WALDEN PRESERVE 2 – FILING 5 AMENDMENT AND FILING 6

MAJOR PLANNED UNIT DEVELOPMENT AMENDMENT

V1_PUD Development Plan - can include phasing if proposed.pdf Markup Summary

DESIGN: NQJ
REVIEW: REB
DATE: 08/31/2026
H-SCALE: 1" = 80'
V-SCALE: N/A
SHEET
4 OF 11
PCD FILE NO:

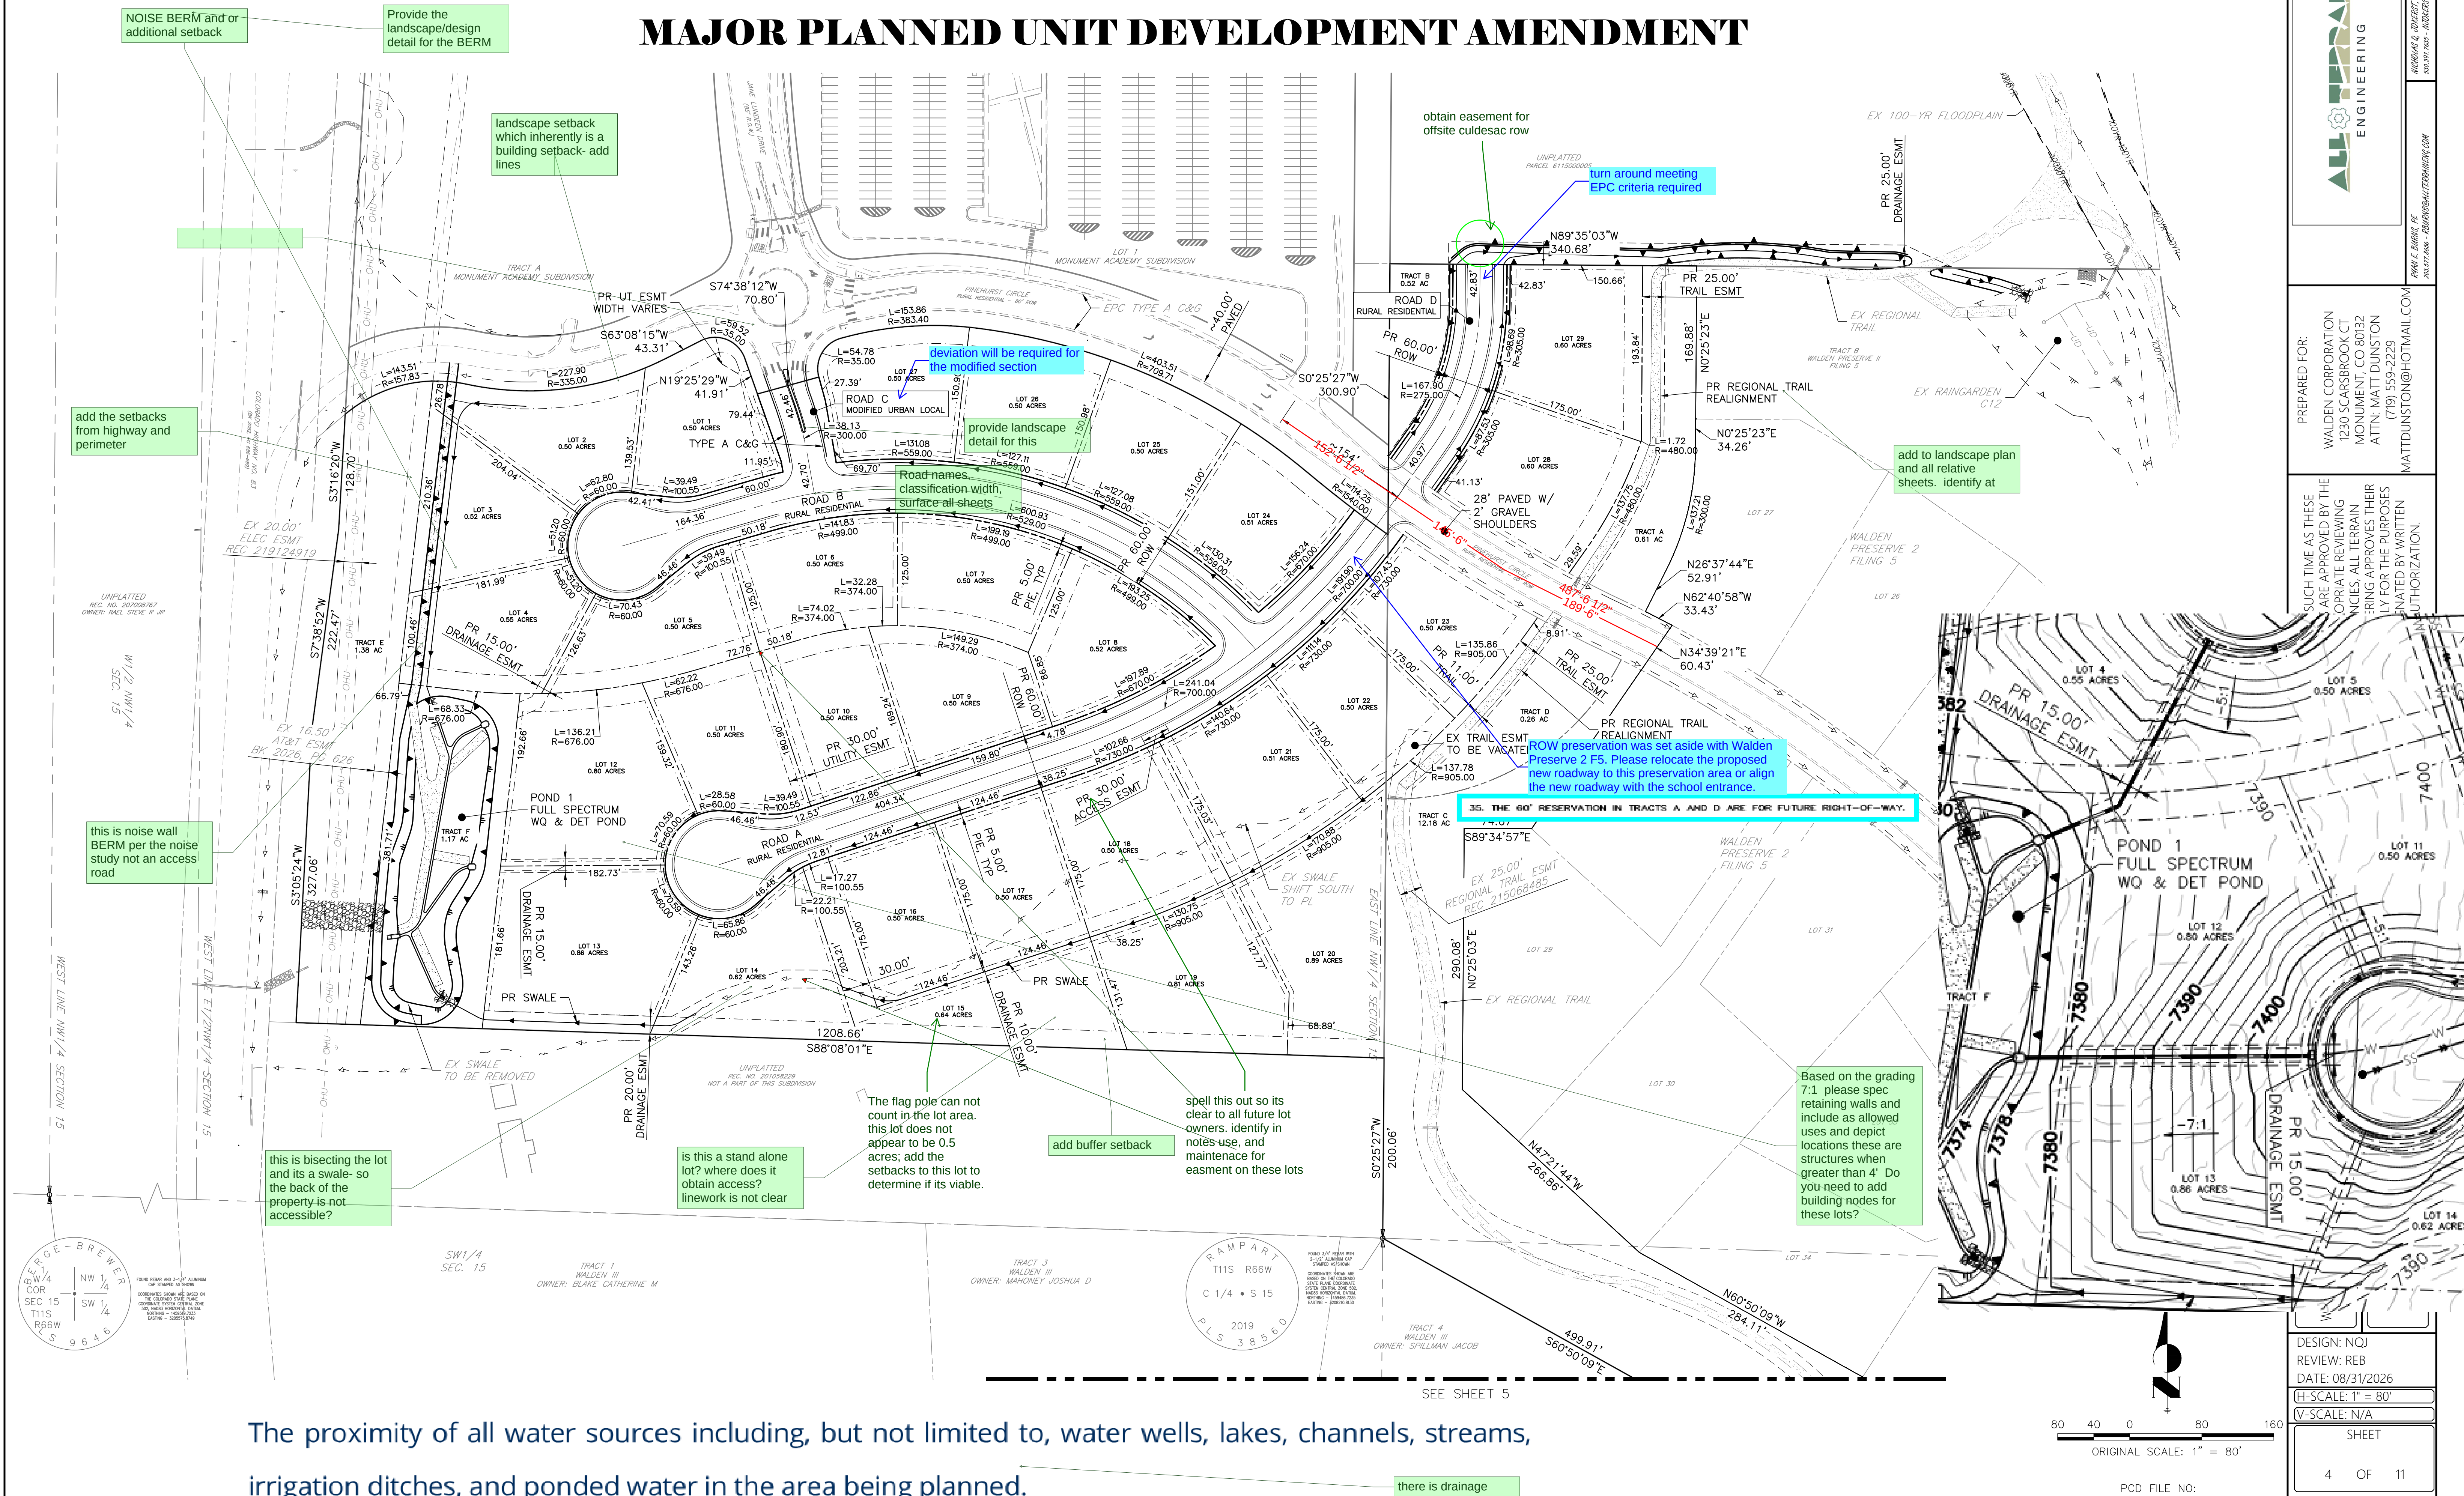
deviation request will be required for the modified section.

deviation will be required for the modified section

add to landscape plan and all relative sheets.
identify at

add the setbacks from highway and perimeter

add buffer setback

landscape setback which inherently is a building
setback- add lines

provide landscape detail for this

The flag pole can not count in the lot area. this lot
does not appear to be 0.5 acres; add the setbacks
to this lot to determine if its viable.

Based on the grading 7:1 please spec retaining walls and include as allowed uses and depict locations these are structures when greater than 4'
Do you need to add building nodes for these lots?

Provide the landscape/design detail for the BERM

WALDEN PRESERVE 2 - FILING 5 AMENDMENT AND FILING 6	PRELIMINARY UTILITY PLAN
--	---------------------------------

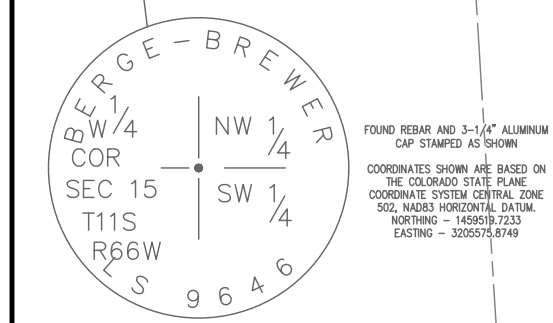
A structure will be required at this location to accommodate the change in pipe direction.
